Product Change Notice

(PCN Tracking Number: EE-QR-220627-01)

Customer:	ALL Customers
Renesas Product Type:	RA2E1 series (please refer to last page for more details)
Description of Change:	Addition of wafer fab, assembly & sorting sites
Reason for Change:	To ensure stable production supply
Identification:	Identifiable via production history data on the packing label or trace code
Schedules:	Sample order deadline: e/o July 2022 Sample delivery: m/o Oct. 2022 (onwards and upon request) Reliability report: m/o Jan. 2023 (upon request) Requested approval e/o Jan. 2023 Change Implementation e/o Jan. 2023 onwards
Anticipated Impact:	Spec. & Characteristic: No impact Quality & Reliability: No impact
Doc. No.:	EE-QC-PCN-CR-22-0150
Internal Reference:	MCP-AC-22-0020

7mm×7mm 0.5mm pitch 48pin LFQFP package outline (RSB)

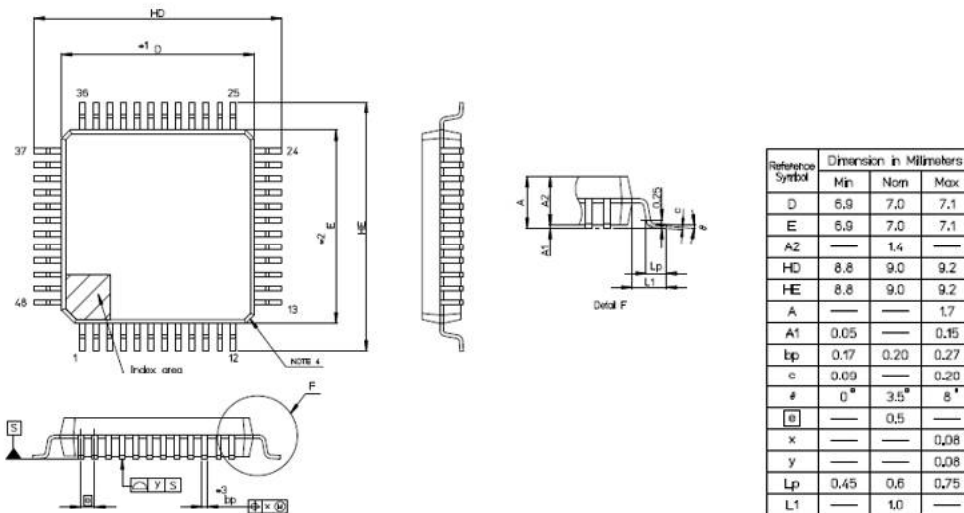
Comparison: 7mm×7mm 0.5mm pitch 48pin LFQFP package

Greatek package symbols comply JEDEC standard.

10mm×10mm 0.5mm pitch 64pin LFQFP package outline (Greatek)

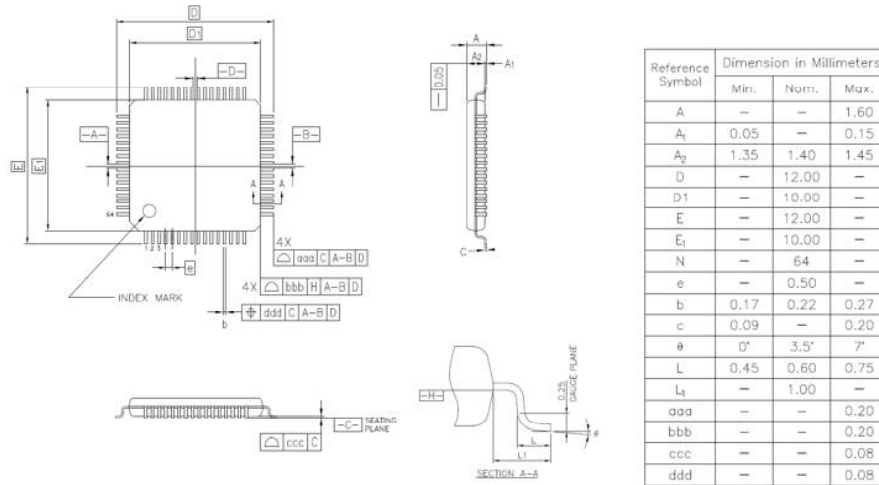
Comparison: 10mm×10mm 0.5mm pitch 64pin LFQFP package

Greatek package symbols comply JEDEC standard.
